January 17, 2006
AET 06-0008

**American Centrifuge Plant
Docket Number 70-7004
Submittal of Planned Changes for the License Application and Supporting Documents for the
American Centrifuge Plant (TAC Nos. L32306, L32307, and L32308)**

Figure 2.1-1
American Centrifuge Plant Organization Chart

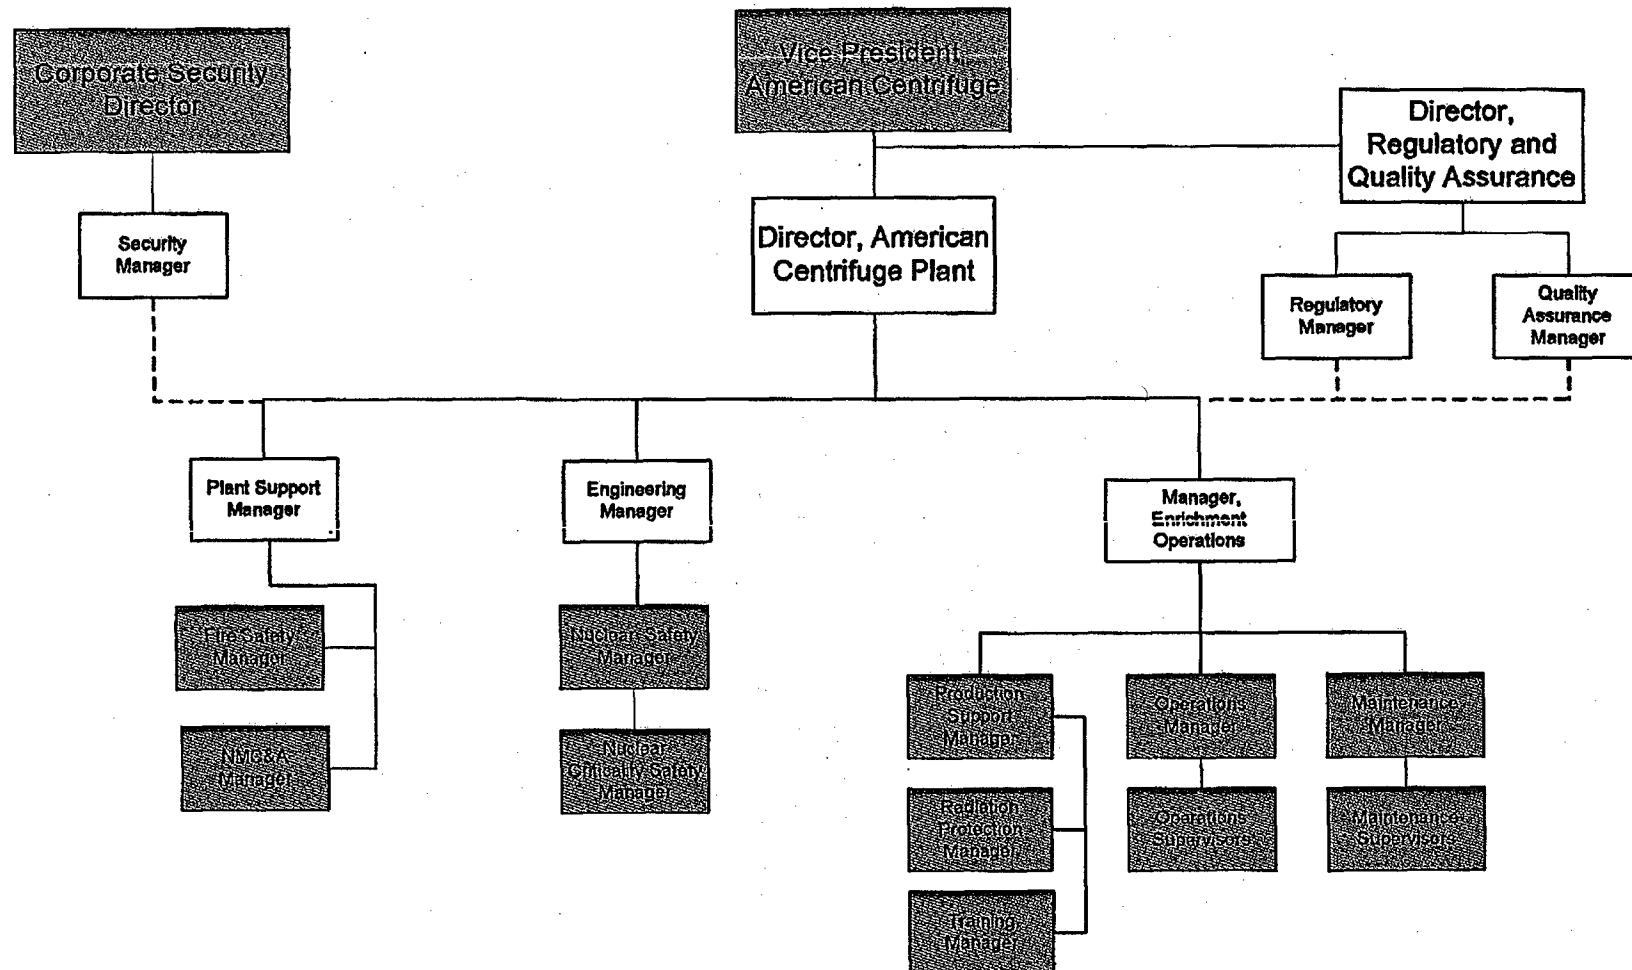
In addition to the changes noted in Reference 1, additional changes have been made to Chapters 2.0 and 4.0 of the License Application and Quality Assurance Program Description to incorporate USEC's latest organizational changes. Also, in Chapters 1.0, 3.0, and 4.0 of the License Application there are planned changes to incorporate clarifications discussed with the NRC staff in the topical areas of radiation protection and initial conditions. Revision bars in the right-hand margin depict changes from the previous version submitted to the U.S. Nuclear Regulatory Commission.
